**DRAFT GLOBAL TECHNICAL REGULATION (gtr)
 ON WORLD-WIDE HEAVY-DUTY CERTIFICATION (WHDC)**

OICA Comment on ECE/TRANS/WP.29/GRPE/2006/9,
 Chapters 7.8.3.2. (Hot Soak Procedure) and 7.8.3.3. (Hot Start Test)

Example of exhaust temperature during real driving conditions of a vehicle:

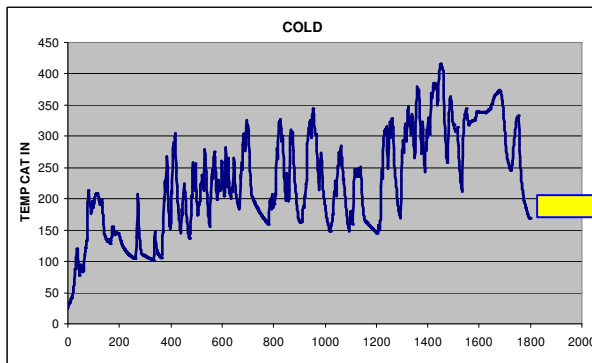
The example shows typical driving conditions consisting of cold start, re-start, warm-up and in-use conditions. Translating these conditions into the emission test procedure, the cold WHTC should cover cold start, warm start and warm-up conditions. The weighting factor does take care

of the importance of the cold start and should be based on the analysis of real vehicle data. On the other hand, the in-use conditions should be represented by the hot WHTC (normal in-use conditions) and a weighting factor correlating with field data. A 20 minute soak period in front of the hot test does not represent such in-use conditions.

Cold test followed by hot test without any interval

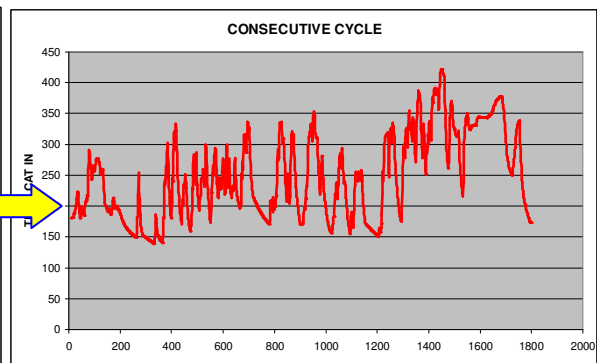
The aim of this test is to demonstrate the real ‘in-use’ conditions in the second test, following the previously explained principle. The hot test starts at exactly the same temperature conditions as the first test ended. As there is idle at the end and beginning of any test (again for test management reasons), there is a short cooling-down phase. As this consecutive testing is not manageable, an engine-conditioning has to be defined for the hot test.

Cold test followed by hot test with conditioning at WHSC mode 9

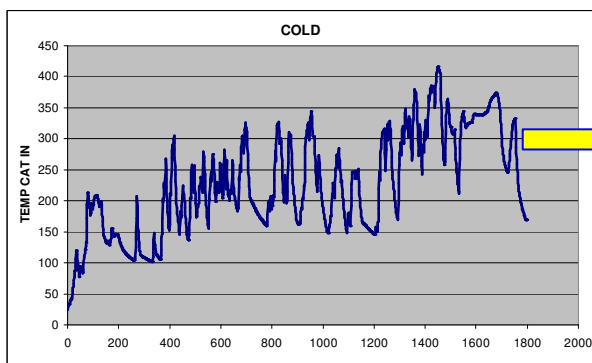
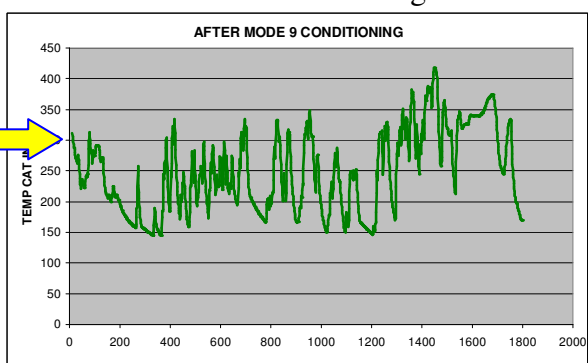
It has been found that preconditioning at WHSC mode 9 (medium speed and medium load) of max 10 minutes provides conditions for good repeatability and reproducibility and represents in-use conditions (not taking into account the idling periods needed for test purpose only)

It is proposed and supported by data, that for the hot WHTC and the standard WHSC a preconditioning of the engine system of max. 10 minutes at WHSC mode 9 is introduced in the WHDC test protocol. Weighting factors of cold and hot test should be defined based on field data.

Cold test followed by 20 minutes soak and hot test

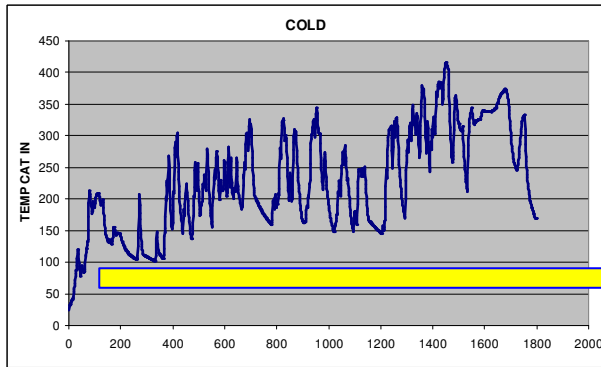
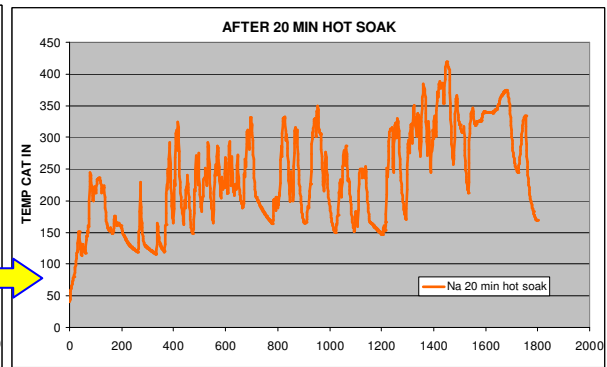
The conditions as proposed by the US-EPA have been run with the same engine system. As it can be seen, the ‘hot’ test performs the same way as the cold test up to more than 400 seconds of the test and is therefore no representative if in-use driving conditions. As mentioned before, the influence of cold and warm start is to be dealt with by the cold start weighting factor.

Comparison with vehicle in-use data

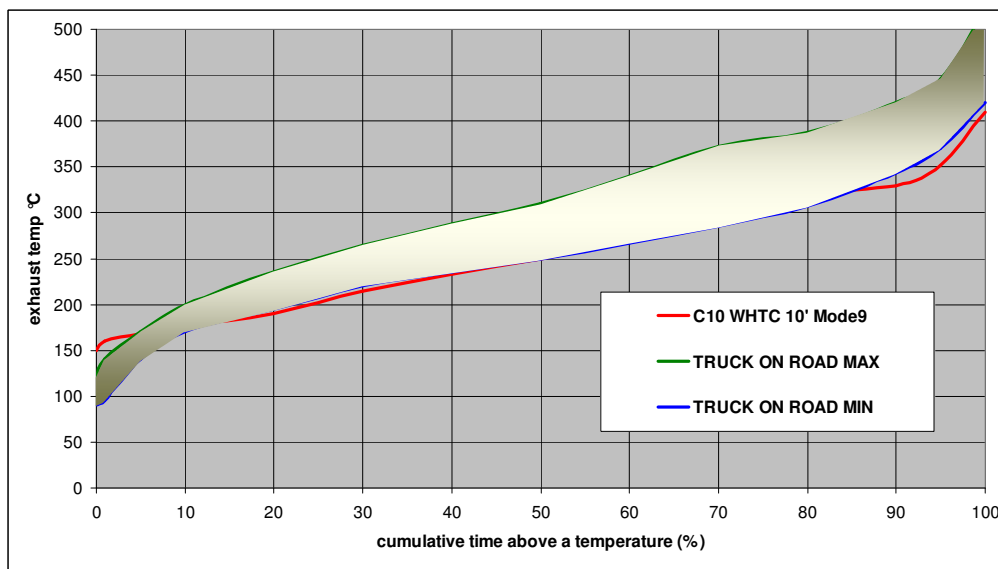
Typical truck driving behaviour has been re-evaluated and compared, from a temperature profile point of view, with a 10 minute WHSC mode 9 preconditioned WHTC. The truck data includes city, rural, highway and freeway driving conditions. The mode 9 preconditioned WHTC follows for 90% of the cumulative time the min temperature profile and it can be concluded, that still the worst condition for the aftertreatment system is being tested when preconditioning the engine system for 10 minutes at mode 9 in front of the hot test.
